REMARKS

RE: THE DRAWINGS

FIG. 8

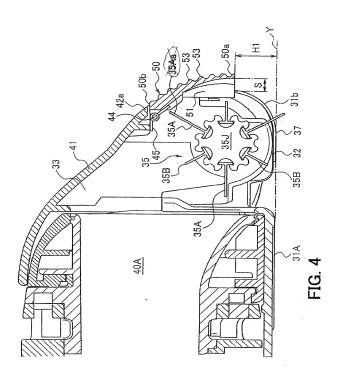
Fig. 10 has been amended to be labeled as "PRIOR ART" as required by the Examiner, and Figs. 4, 8 and 9 have been amended to remove reference numeral "35Aa". In addition, it is noted that the specification has been amended at paragraph [0031] to delete reference numeral "40a" and the specification has been amended at paragraphs [0027] and [0031] to mention reference numeral "40A" shown in Figs. 4-6. Accordingly, it is respectfully submitted that the Examiner's objections to the drawings have been overcome. Submitted herewith are corrected sheets of formal drawing which incorporate the amendments and annotated sheets showing the changes made thereto.

With this structure of the claimed present invention, as shown in Figs. 8-9, when the suction inlet unit (30) is advanced forward to press the cover (50; the first part of the wall section) against the wall (K), the cover (50) is rotated by the adjusting mechanism in the clockwise direction of Fig. 8 and the

non-rotatable front end surface (Va) of the bumper (V) comes into contact with the wall (K) to prevent further inward rotation/movement of the cover (50). As a result of the rotation, the opening area of the front suction inlet (46) decreases and a part the longer cleaning members (35A) on the rotating cleaning body (35) protrudes out through the front suction inlet (46) ahead of the cover (50) as shown in Fig. 9.
